December 3, 2014

RE: Changes to SE-330 Series Neutral-Grounding-Resistor Monitors

This letter is an update to the PCN (March 31, 2014) for the SE-330, SE-330HV, and SE-330AU Series NGR Monitors. New revisions of each series include:

Figure 1. New and Old SE-330 Faceplates.

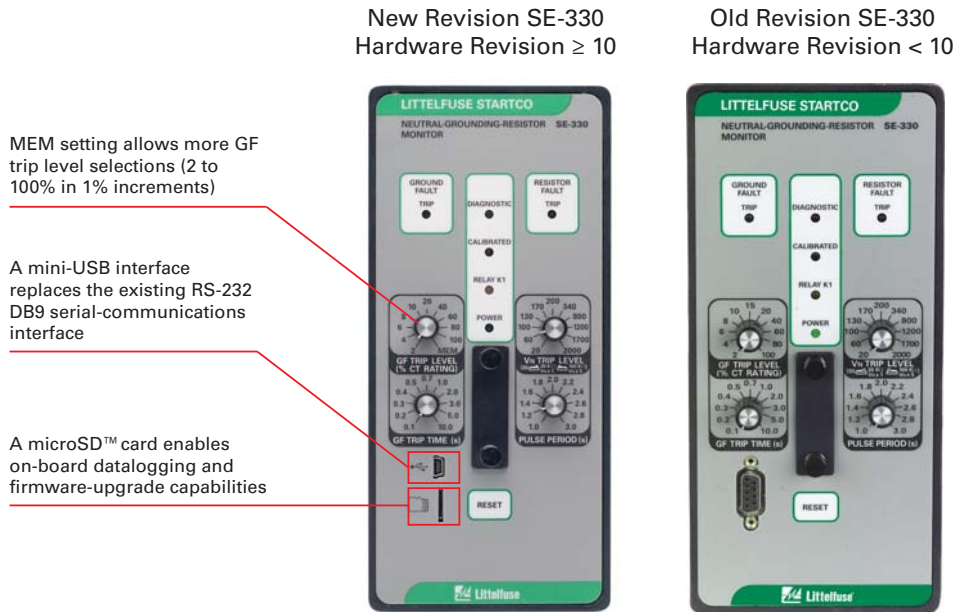
- 100-event data log with time-and-date stamp, replacing 10-event non-time-stamped data logger
- A mini-USB interface replacing the existing RS-232 DB9 serial-communications interface
- A microSD™ card slot to increase data-storage and firmware-update capabilities
 - A microSD™ card is included
- Programmable ground-fault pickup setting to extend the previous setting range
- Selectable fail-safe or non-fail-safe indication-relay operating modes
- New Ethernet communication options:
 - IEC 61850 protocol support (substation communication protocol)
 - Dual ports with two IP addresses
 - Wired or fiber connections
- SE-330-SMA Surface-Mount Adapter will be an ordering option, no longer included with the SE-330 and SE-330HV Series (SE-330AU models did not include the adapter)

The new SE-330 faceplate is shown in Fig. 1 and ordering information is shown in Fig. 2.
